# ADDISON TRANSIT CENTER PARKING LOT EXPANSION

C-96000124-28

PRELIMINARY
SUBMITTED FOR REVIEW
BY Charles E. Bennett, P.E.    P.E. 68613
<b>Turner Collie &amp; Braden Inc.</b>
Date                      NOVEMBER 2001
NOT FOR CONSTRUCTION, BIDDING OR PERMITTING PURPOSES

(Darts Internal  
Review Comments)

ADDISON  
TRANSIT CENTER  
SITE PLAN

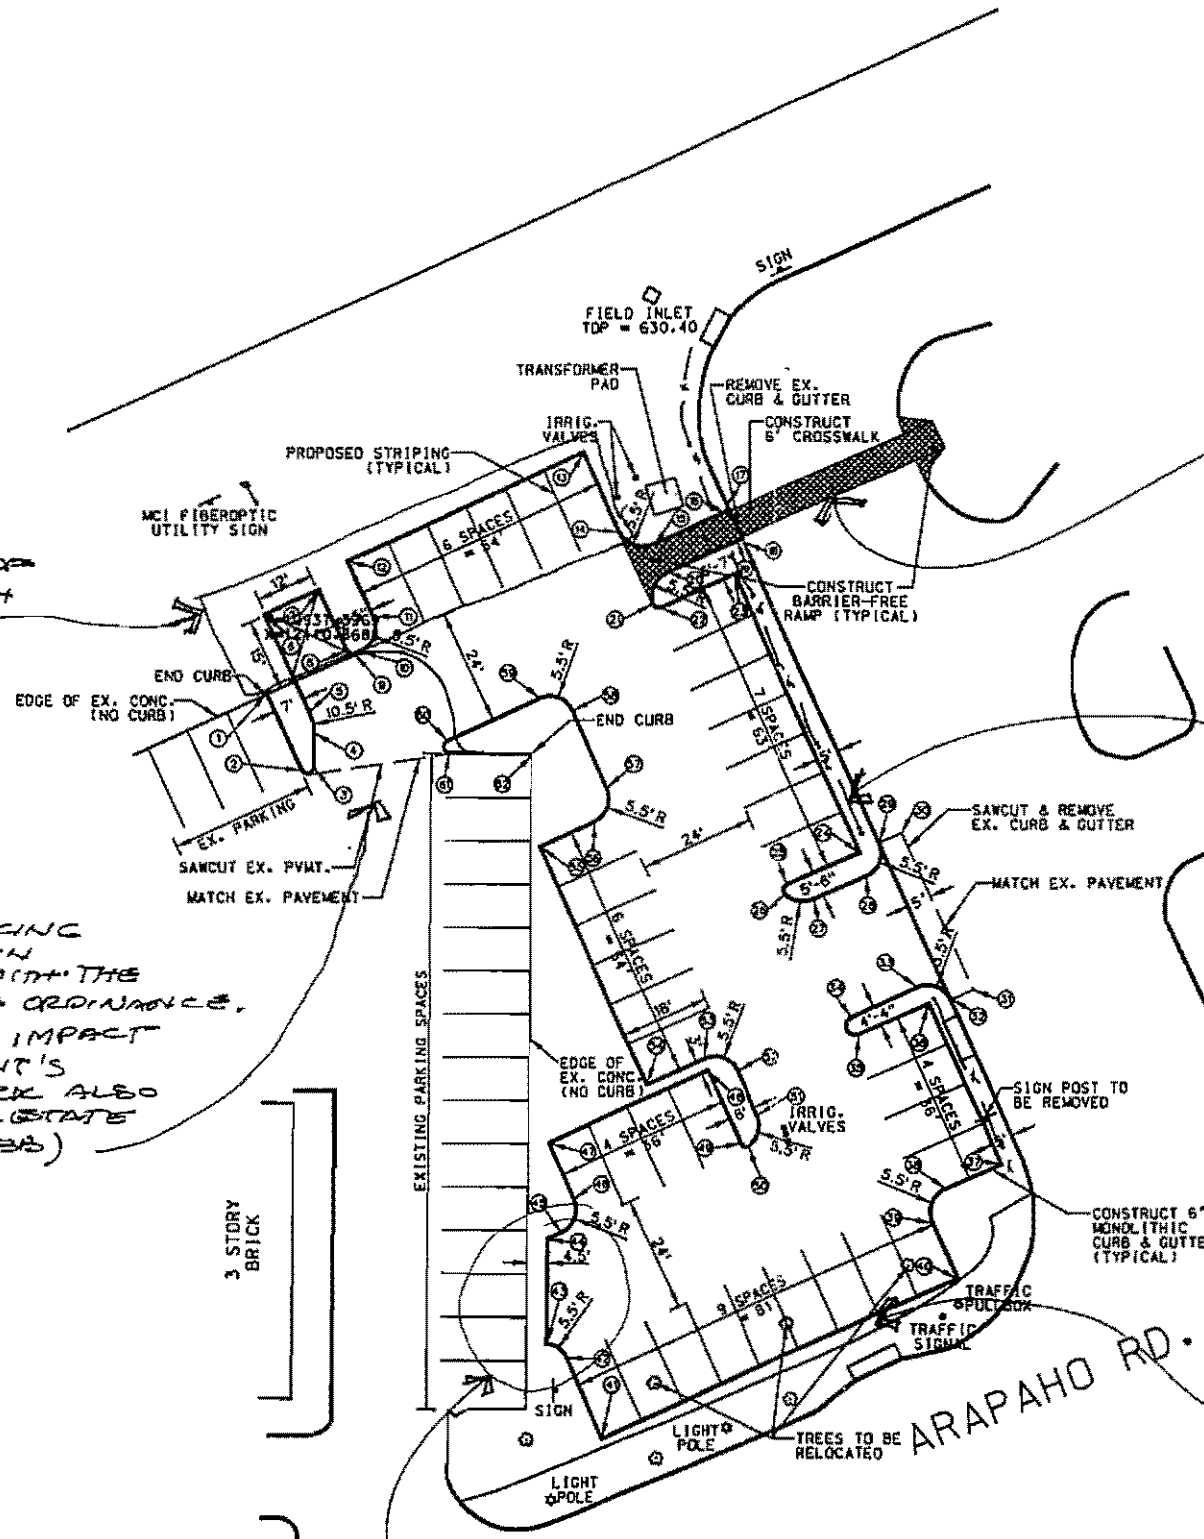
VERIFY THE USE OF  
THIS R.O.W., WITH  
JAN SEIDNER

VERIFY THAT PARKING  
CONNECTION IS IN  
ACCORDANCE WITH THE  
T.O.A. PARKING ORDINANCE.  
SPILLOVER MAY IMPACT  
BUILDING TENANT'S  
PARKING. CHECK ALSO  
WITH OAK RIDGE STATE  
DEPT. (RON WEBB)

VERIFY WITH TOWN OF ADDISON (T.O.A.)  
THAT DEAD END PARKING IS PERMITTED

VERIFY THE SAFETY OF  
THIS CROSSING WITH BUS  
OPERATIONS. IF APPROVED, THIS  
CROSSING SHOULD MATCH THE ONE  
AT THE OPPOSITE END OF BUS PLAT FORM.

PROVIDE  
RAILING TO MATCH  
OPPOSITE SIDE OF  
FACILITY

DRAWING PACKAGE SHALL  
INCLUDE:

- REMOVAL/RELOCATION OF EXISTING IRRIGATION HEADS AND ANY OTHER EXISTING ELEMENTS,
- DRAINAGE
- ILLUMINATION/LIGHTING
- FENCE OR RAILING REQUESTED BY THE TOWN OF ADDISON
- SIGNAGE
- ADA REQUIREMENTS FOR ADDITIONAL SPACES, AS NEEDED. SPACES SHALL BE DESIGNATED AND CLEARLY IDENTIFIED
- LANDSCAPING

VERIFY LANDSCAPING  
REQUIREMENT WITH T.O.A.  
ADJACENT TO STREET  
AND THROUGHOUT PARKING  
AREA

ADDISON  
TRANSIT CENTER  
SITE PLAN

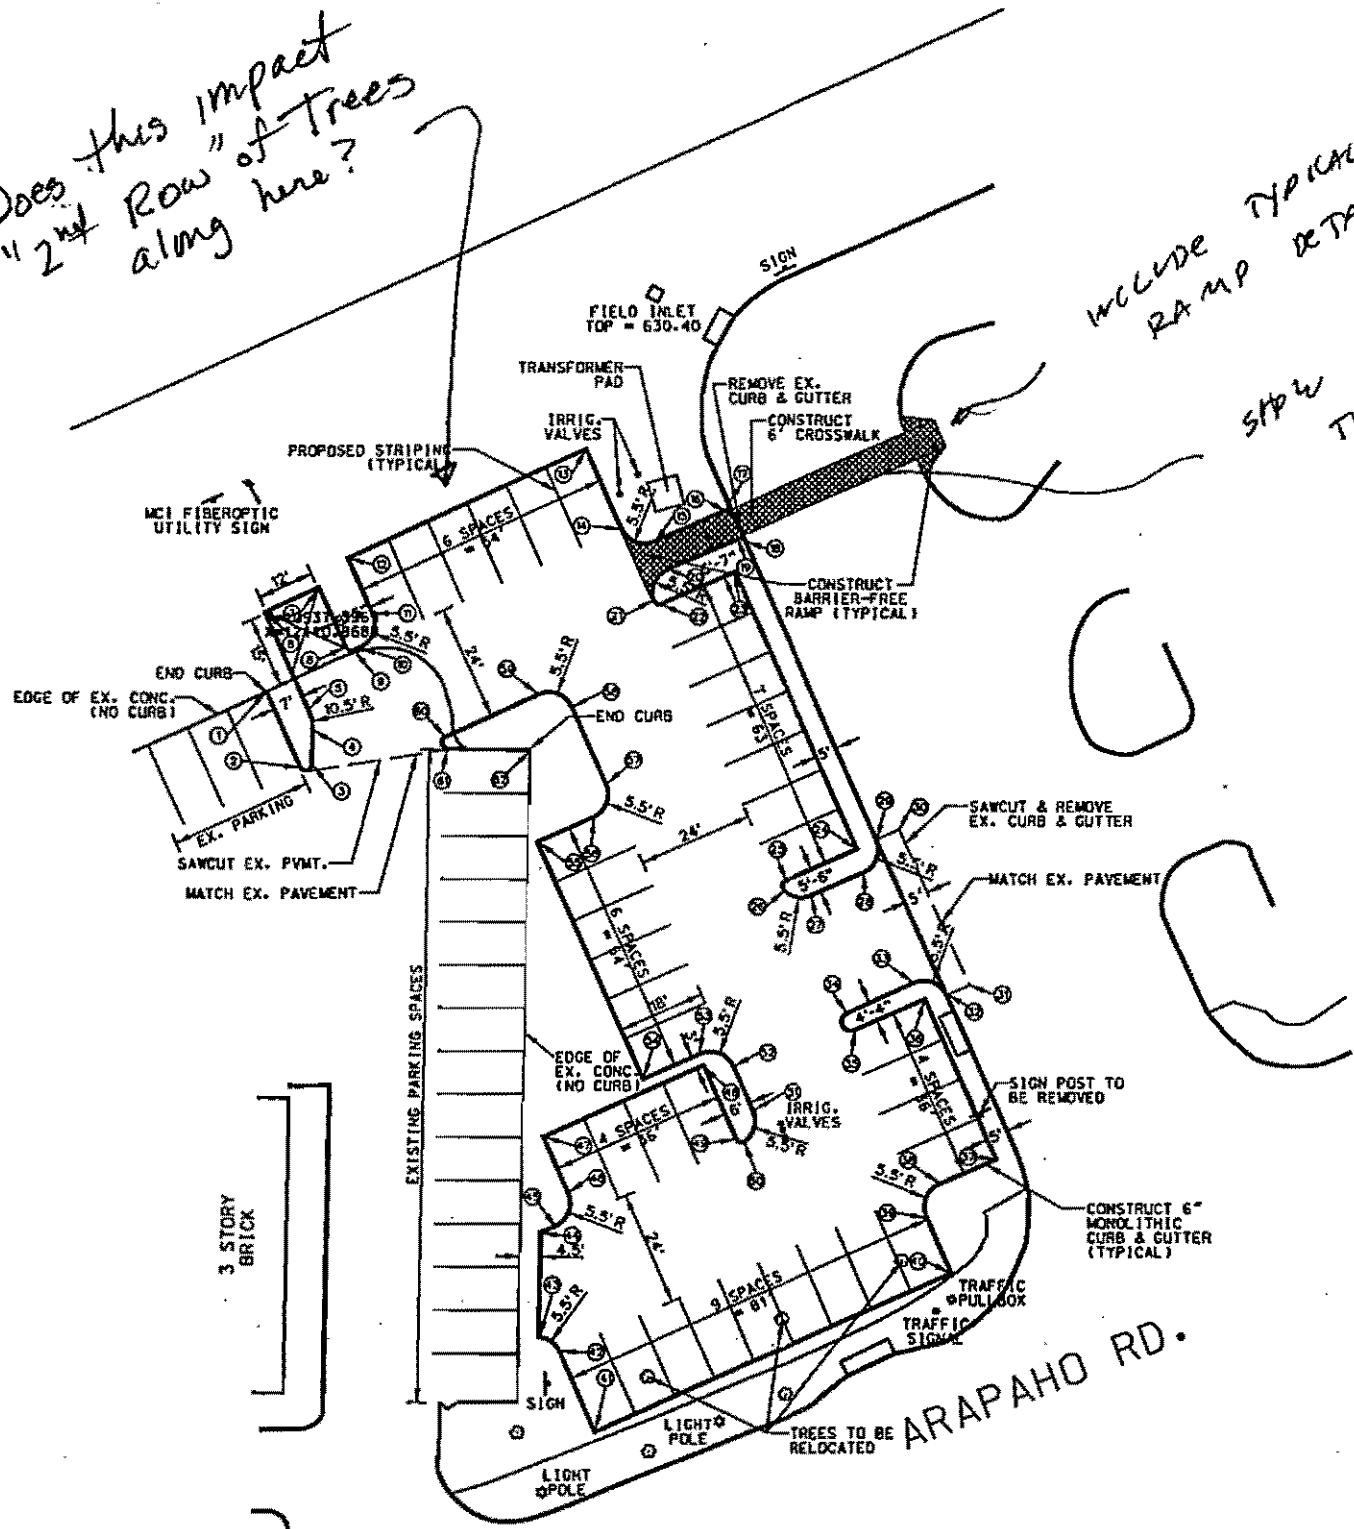
*Does this impact  
"2nd Row" of trees  
along here?*

*INCLUDE TYPICAL ADA  
RAMP DETAIL*

*SHOW DETAIL OF WIDTH,  
TYPE, COLOR, ETC. OF  
CROSS-WALK.*

*SHOW EXIST UTILITIES &  
ASSOCIATED SERVICE  
LINES ON SITE PLAN (i.e., water,  
sewer, etc.)*

*SHOW TYPICAL DRIVE  
APPROACH DETAIL!*

*SHOW TYPICAL concrete  
CURB + GUTTER SECTION*

**ADDISON  
TRANST CENTER  
DRAINAGE &  
GRADING PLAN**

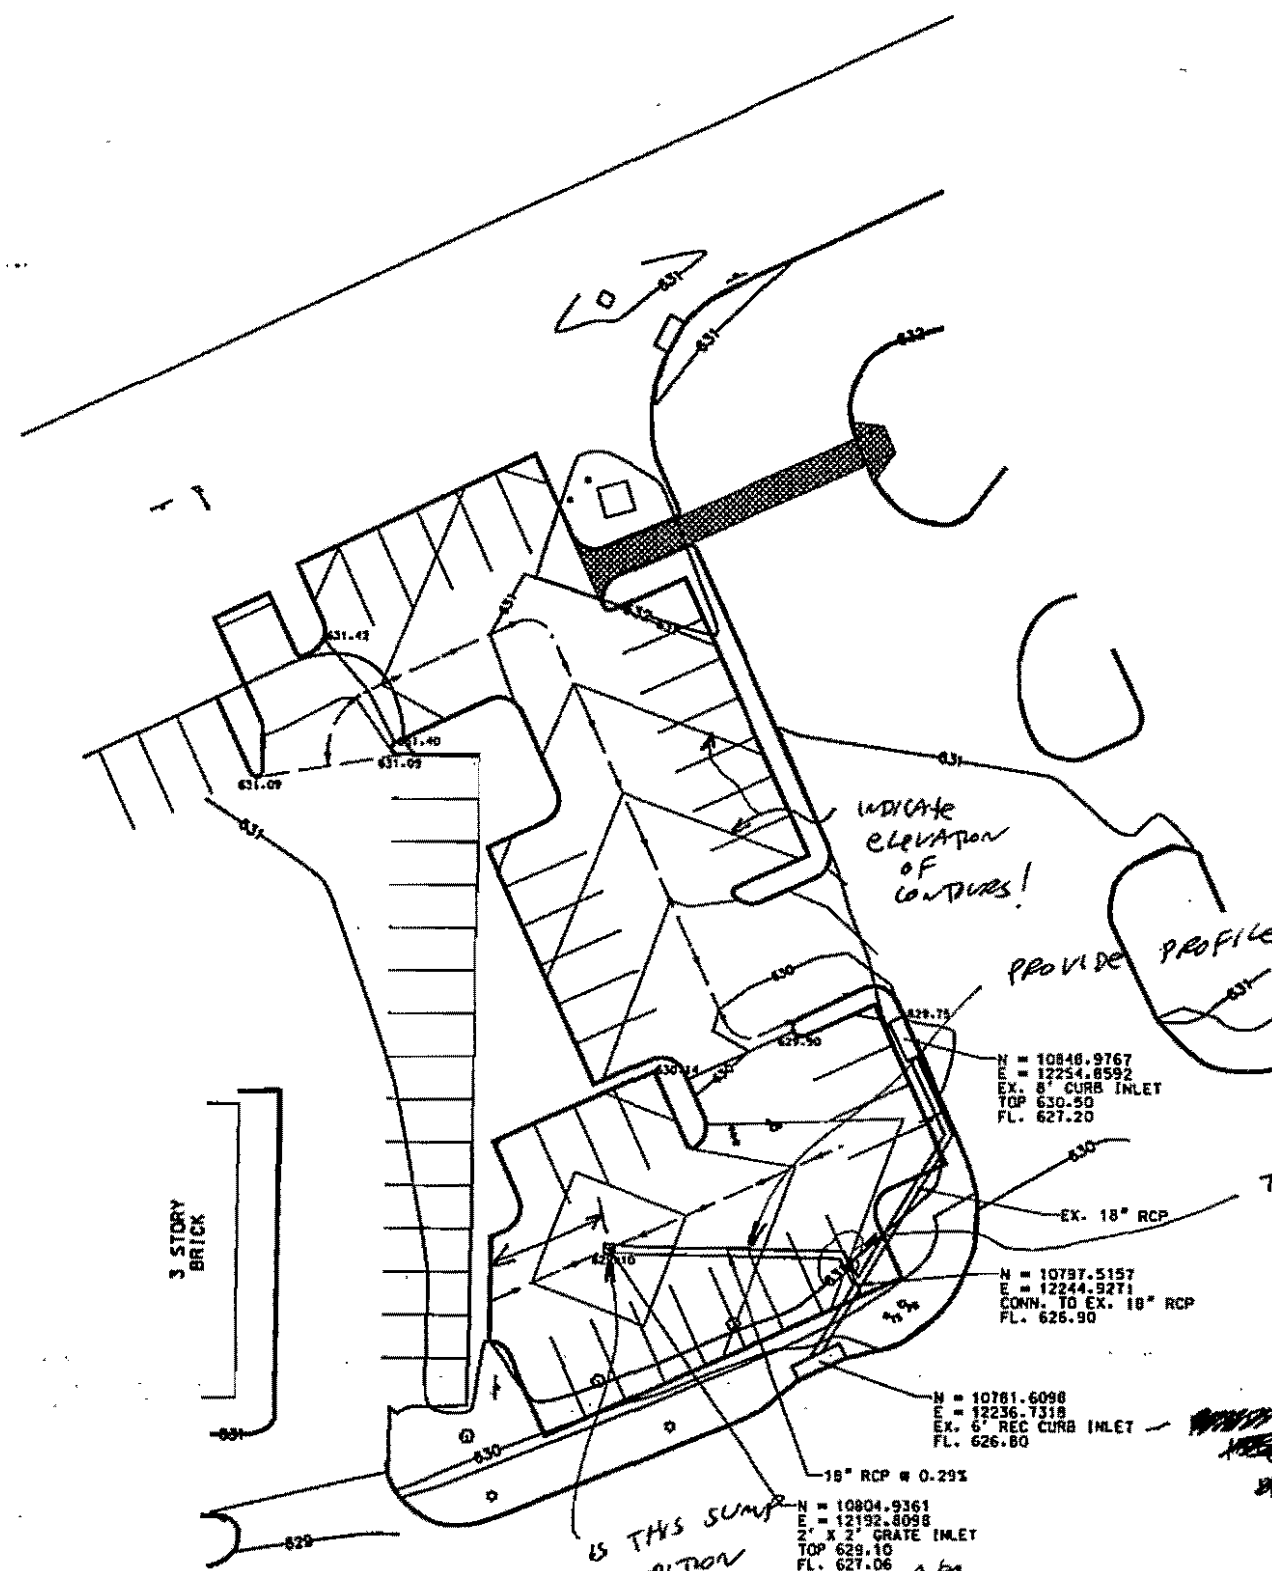
- SHOW: 1. DRAINAGE SUB-AREAS  
2. FLOW CALCULATIONS  
3. CAPACITY OF SWALE IN PARKING LOT TO HANDLE Q.  
4. ON-SITE RETENTION LOCATION & CALCULATIONS

PROVIDE PROFILE OF PROP. 18" R.C.P. WITH DETAIL OF CONNECTION TO EXIST. 18" R.C.P.!

& SHOW EMBEDMENT + BACKFILL DETAIL OF PROP. 18" R.C.P.

TAKE OUT BEND IN PIPE!

IS THIS SUMP CONDITION ALSO A STORMWATER DETENTION AREA?
